UNITED STATES PATENT AND TRADEMARK OFFICE

APPLICATION NO.	FILING DATE	FIRST NAMED INVENTOR	ATTORNEY DOCKET NO.	CONFIRMATION NO.
10/785,672	02/23/2004	Michael P. Whitman	H-PM-00024 (1800-24)	2683
91478	7590	07/06/2010	EXAMINER	
Tyco Healthcare Group LP 60 Middletown Avenue North Haven, CT 06473			WEEKS, GLORIA R	
ART UNIT	PAPER NUMBER			
	3721			
MAIL DATE	DELIVERY MODE			
07/06/2010	PAPER

DETAILED ACTION

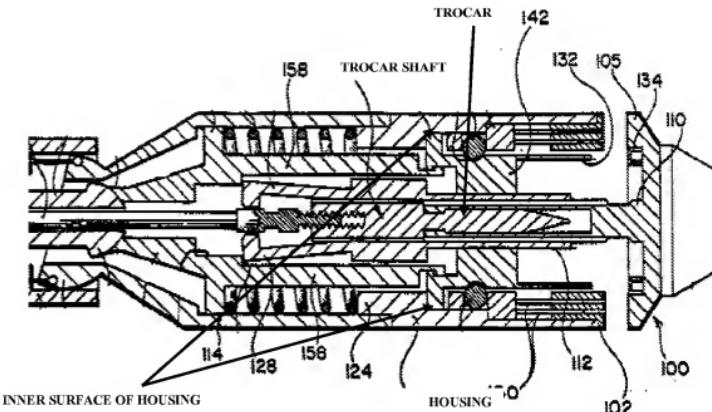
In reference to claims 100, 102-104 and 106-109, Grant et al. discloses a surgical device, comprising: a staple housing 104 receiving a stapler cartridge 102, the housing 104 having an inner surface defining a bore (*see diagram of Grant et al. figure 18 below*) ; a rim 112 extending radially inward from the inner surface 124 of the housing 104 (figure 9-column 11 lines 49-52); a trocar shaft 206 disposed through the bore of the housing 104 and extends distally¹ relative to a clamping face (figures 6-7), so as to be moveable relative to the housing 104 by operation of at least one driver 84 by a first rotatable drive shaft 96, wherein the at least one driver 84 is within the housing 104; and an anvil 100 attachable to the trocar shaft 206 and configured to be

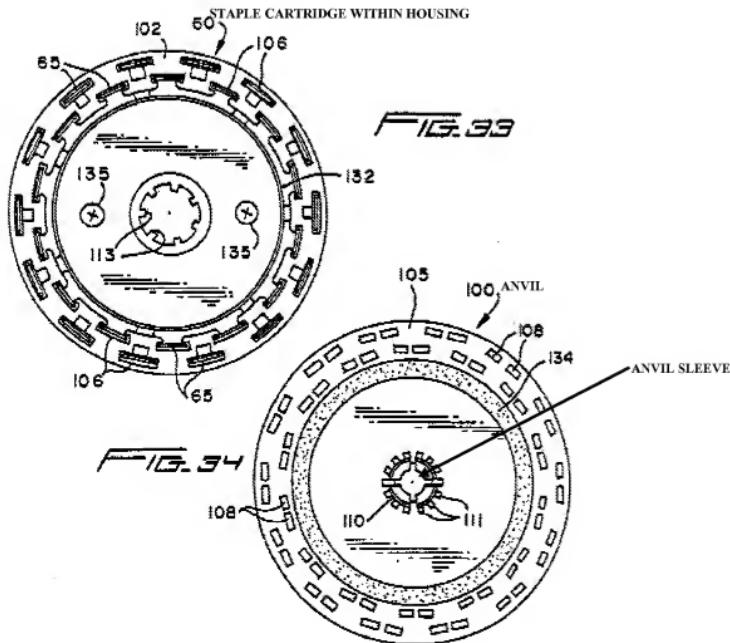
moveable relative to the housing by movement of the trocar shaft, wherein the anvil 100 includes an anvil face 105 and an anvil sleeve 110 defining a trocar receiving slot (see figure 34 diagram of Grant et al. below) and the anvil sleeve 1110 having a circumferential recess (defined by 111 segments-figure 34) receiving portion 113 of the rim 112 (column 13 line 64- column 14 line 14); and a second driver 85 operable a second rotatable drive shaft 92 to drive staples from the staple housing 104.

Although Grant et al. discloses a plurality of recesses 111 that extend radially along the circumference of the anvil sleeve, wherein each recess receives an annular rim of the staples housing. Grant et al. does not disclose a single recess that extends radially around the anvil sleeve. Balazs et al. teaches a staple housing 30 including an inner surface having an annular rim 22 that extends radially within the housing ; and a sleeve 5 extending from an anvil 1, wherein the sleeve 5 has a recess 54 that extends radially around the circumference of the sleeve such that
